# METROPOLITAN GOVERNMENT OF NASHVILLE AND DAVIDSON COUNTY

## STAFF RECOMMENDATION 3501 Byron Avenue, Lot 8 April 16, 2014

**Application:** New construction-infill  
**District:** Elmington Place Neighborhood Conservation Zoning Overlay  
**Council District:** 25  
**Map and Parcel Number:** 10410004700  
**Applicant:** Kevin Smith, Byron Avenue 3501, LLC  
**Project Lead:** Paul Hoffman, paul.hoffman@nashville.gov

**Description of Project:** The application is for construction of a new house on this vacant lot, one of eleven units to be constructed in the Byron Close multi-unit development. The Commission approved the development's property lines and the relocation of Ransom Avenue in July of 2012. Applicant now proposes a single-family house for lot 8 of the development.

Figure 1. Front elevation of proposed infill

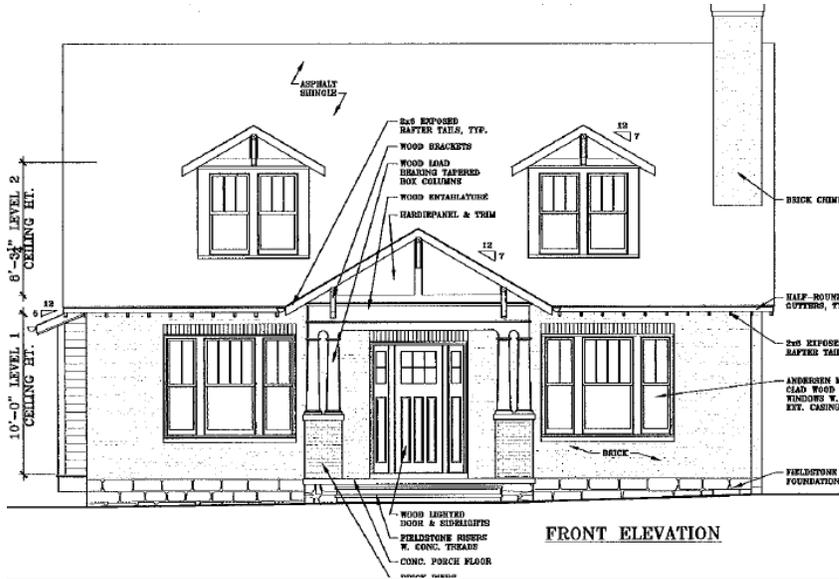
**Height & Scale:** The proposed building is one-and-a-half stories, with a foundation height ranging from one to three feet (1-3'). The eaves will be ten feet (10') from the finished floor height. The ridge height will be approximately twenty-eight feet (28') from grade. The height range for one-and-a-half and two-story homes in the neighborhood is from twenty-two feet (22') to thirty-six feet (36') from grade. The approved houses at lots 3 and 11 of this development are twenty-eight feet (28') and thirty-five feet (35') tall, respectively. The proposed infill is forty-two feet (42') wide, which is within the contextual range of thirty-two feet (32') to forty-eight feet (48'). The proposed building meets section II.B.1 a and b. of the design guidelines.

**Materials, Texture, Details, and Material Color:** The proposed foundation is stone. The building's first story will be brick; the second story will be clad in cement fiber siding with a five inch (5") reveal. The materials for the porch will be stone pedestals with paired round wood posts, concrete treads and porch floor, and brick piers. Trim will be cement fiber panel and wood.

The roof will be asphalt shingles. The color was not indicated and staff recommends they conduct final review of roofing color. The windows are proposed to be aluminum metal-clad wood windows; the door will be wood with sidelights; staff requests final approval of windows and doors. The fence at the right rear corner will have brick posts with six foot (6') cedar privacy fencing. With the condition that staff provides final review of windows, doors, and color of roofing, brick and stone, the project meets section II.B.1.d of the design guidelines.

**Roof Shape:** The proposed shape is a side gabled building with shed dormers on the rear wing and gable dormers on the front. The primary gable form and pitch of 10/12 are found in the district and are appropriate. Staff finds the project to meet section II.B.1.e of the design guidelines.

Staff recommends approval with the condition that Staff provide final review of windows, doors, color of roofing, brick and stone. With this condition, staff finds the project to meet the design guidelines for infill in the Elmington Neighborhood Conservation Zoning Overlay.
